**From:** Gulmohar Residency <info@modiproperties.com>  
**Sent:** 08 April 2023 00:50  
**To:** cr@modiproperties.com; feedback@modiproperties.com;  
kprasad@modiproperties.com; gbrambabu@modiproperties.com;  
gmr@modiproperties.com; sujatmishra@gmail.com  
**Subject:** Complaints And Suggestions from Gulmohar Residency

Project Name : Gulmohar Residency

Flat No/Villa :604

## Details of Additions & Alterations

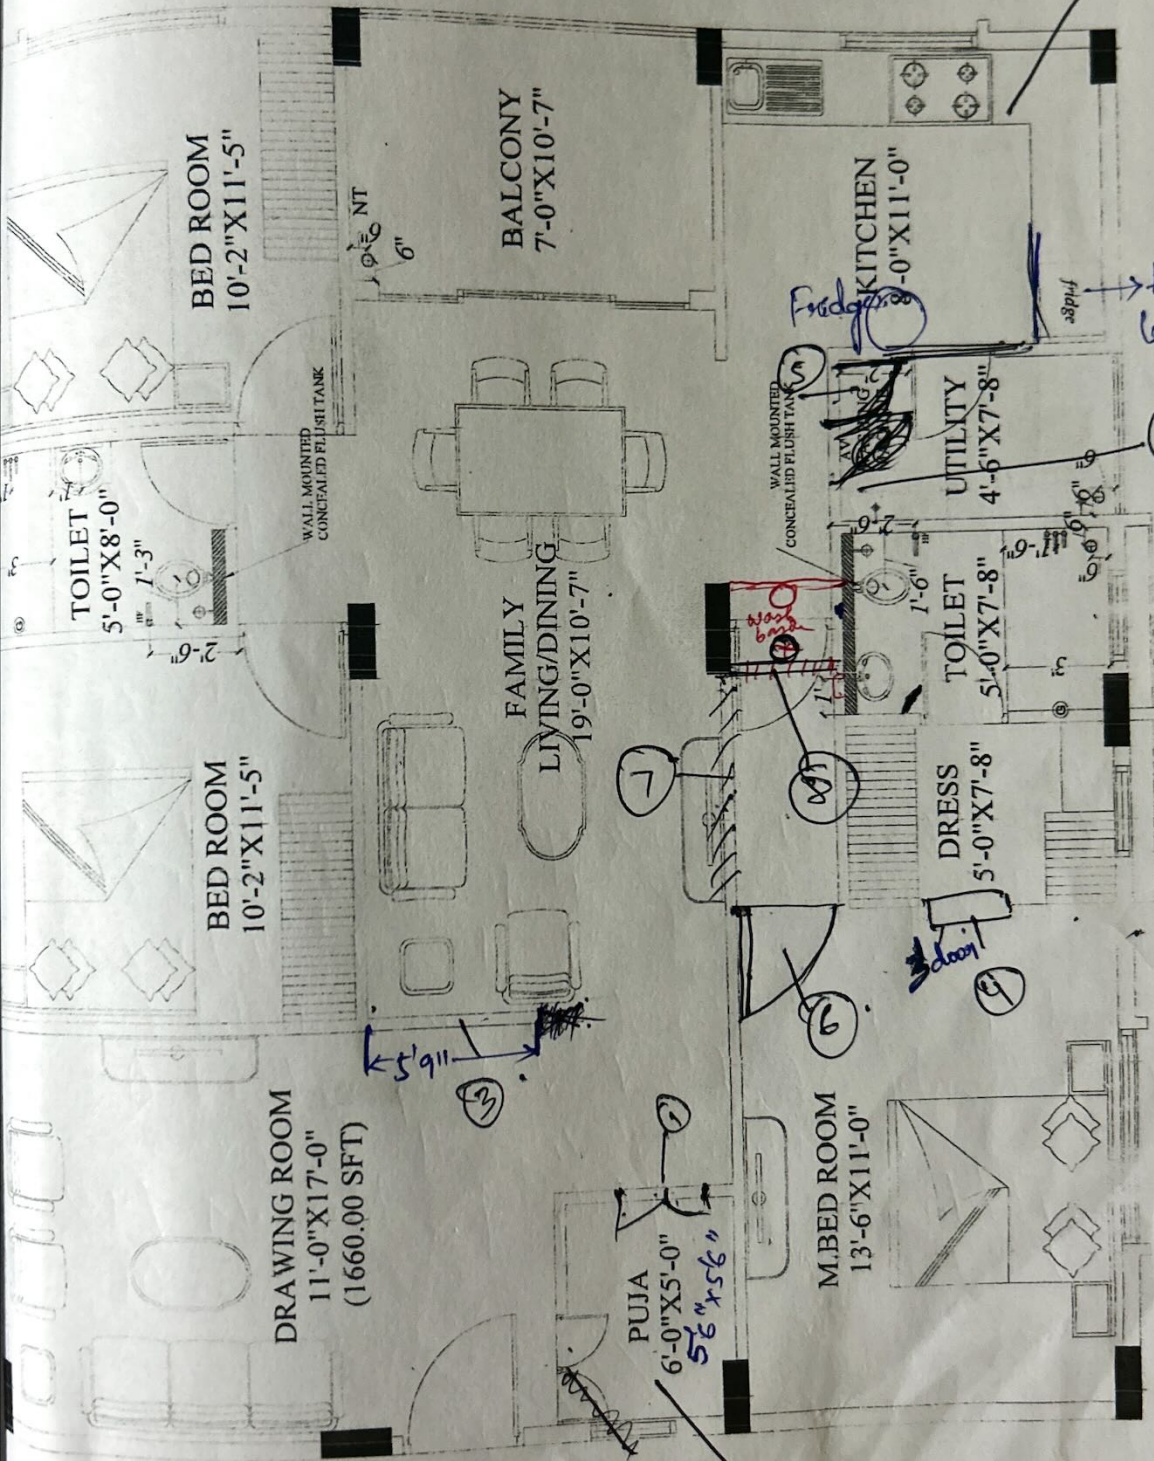
- ① Roof seepage was very high during rainy season  
The same need to be treated and shown to us with water filled a roof.
- ② False roofing tile, need to contact me to add design.
- ③ Master bathroom door position opening to be reversed.  
because the door is dashing with the wash basin <sup>slab</sup> <sup>syhat</sup>
- ④ Granite <sup>of slab</sup> on the kitchen to be put after the completion of modular.

Description	Direction	Owners & Developers	Date	Prepared By	Approved By	Promoted by
WORKING PLAN-1660 Sft - B2 TYPE	N	Modi Realty Mallapur LLP Project Name & Phase : Gulmohar Residency	25.09.2020	Jayapradha	Soham Modi	Modi Properties Pvt Ltd
						N.T.S Phone: +91-48-6633551

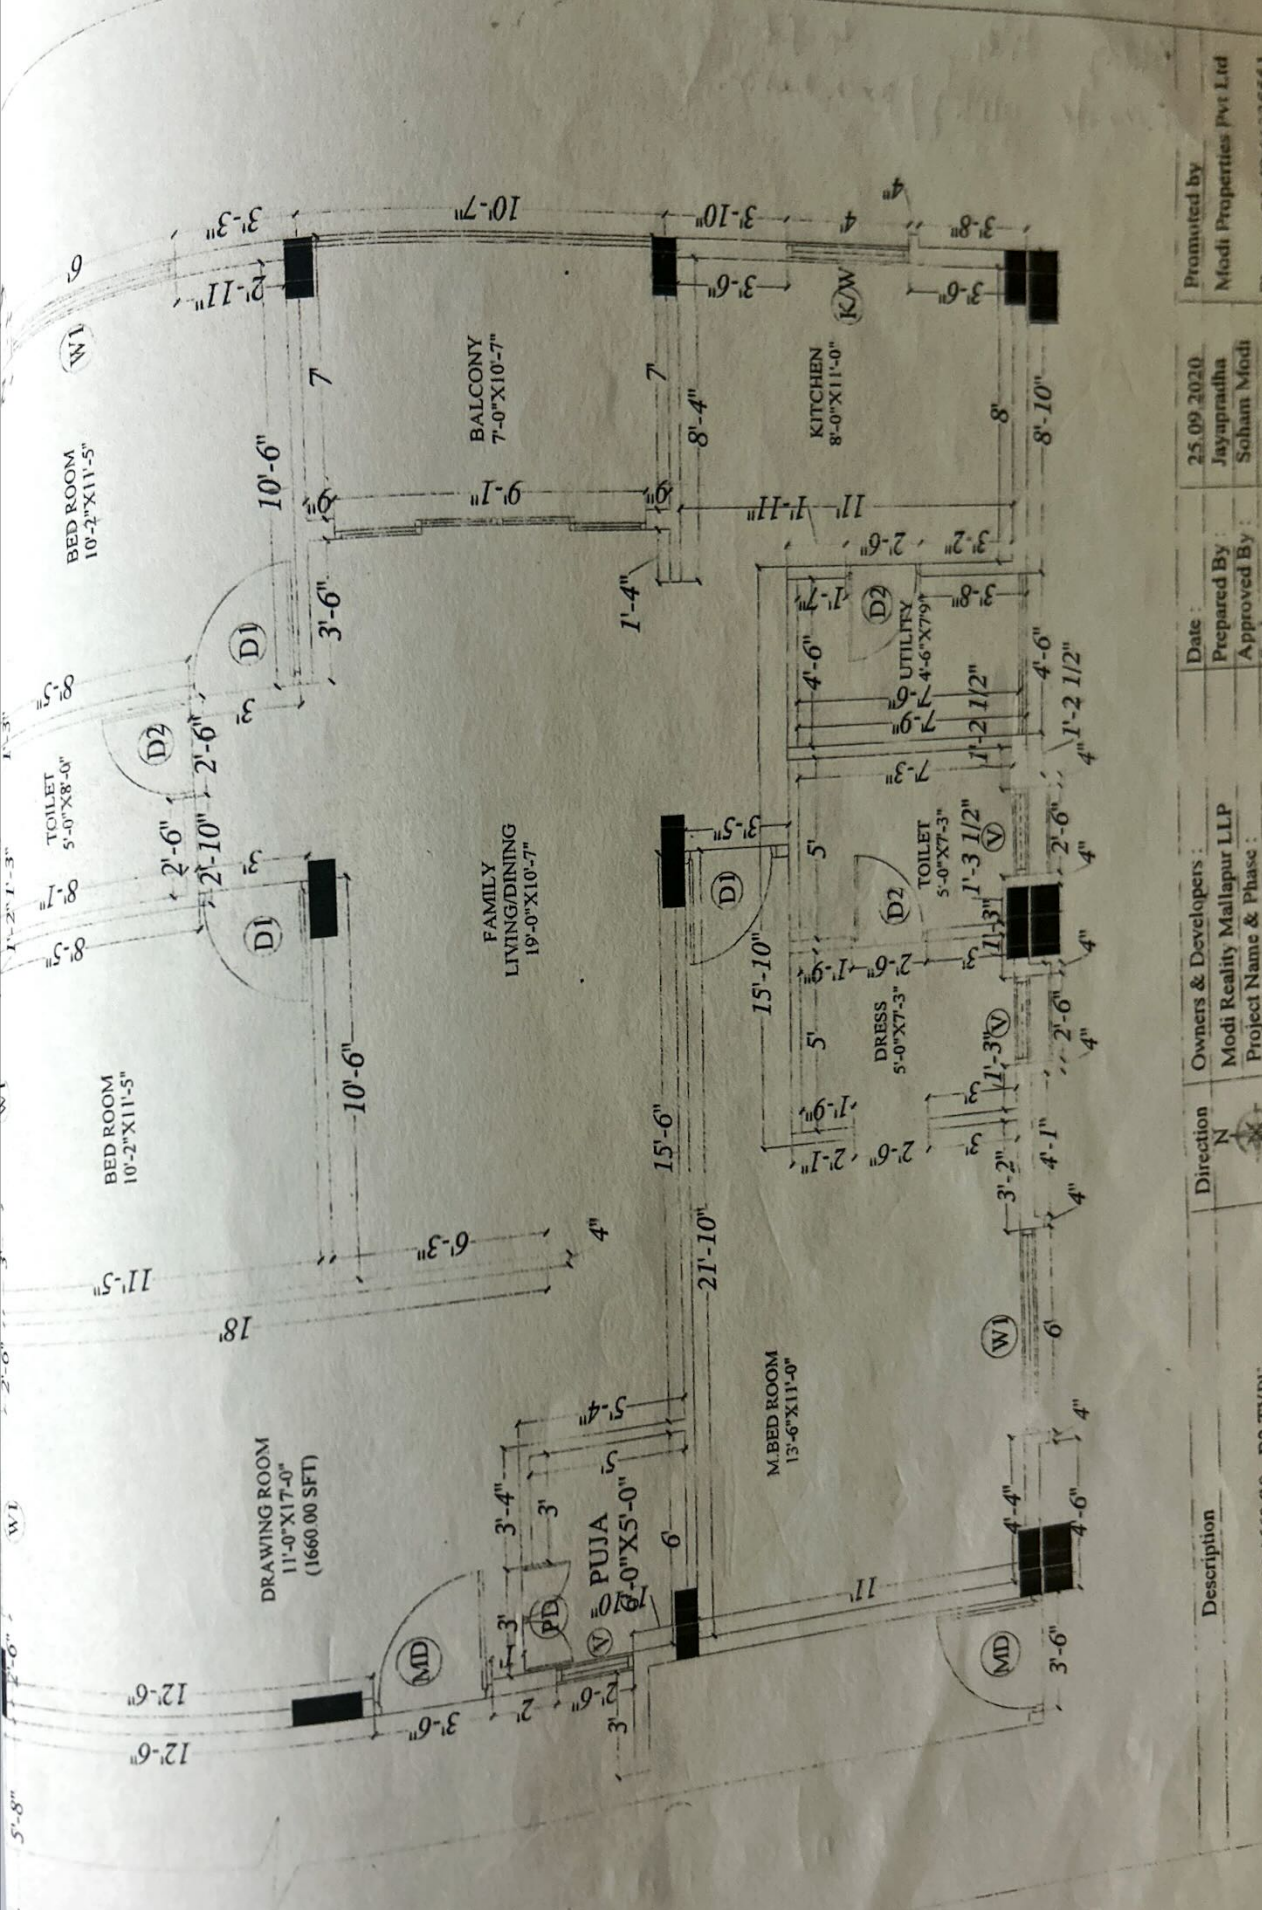
- 1) Pooja room door position has to be changed to <sup>east</sup> ~~west~~ side.
- 2) Pooja Room size 5'6" x 5'6".
- 3) 6'3" wall has to be reduced to 5'9".
- 4) Dress room opening should be 3' instead 2'6".
- 5) Utility door opening to be north side.
- 6) Door position to be placed as per drawing.
- 7) Wall has to be removed.
- 8) Wash basin point of wall has to be raised.
- 9) Kitchen platform has to be placed till the end of the wall (utility).
- 10) No need of platform in utility.
- 11) Wash basin area tile till mirror height.
